CLUTCH TECHNICAL GUIDE

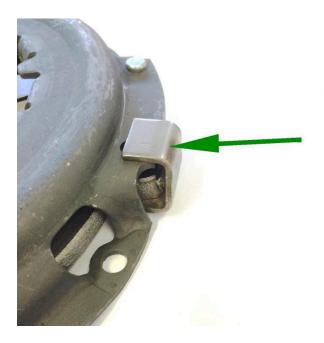
Cover Assemblies do not normally have Clips to retain the pressure plate whilst not installed. The kits covered by this TBC have a Cover Assembly that uses these retaining clips.

The Clips must be removed after bolting the cover assembly to the flywheel.

Remove 3off clips after bolting the Cover Assembly to the Flywheel
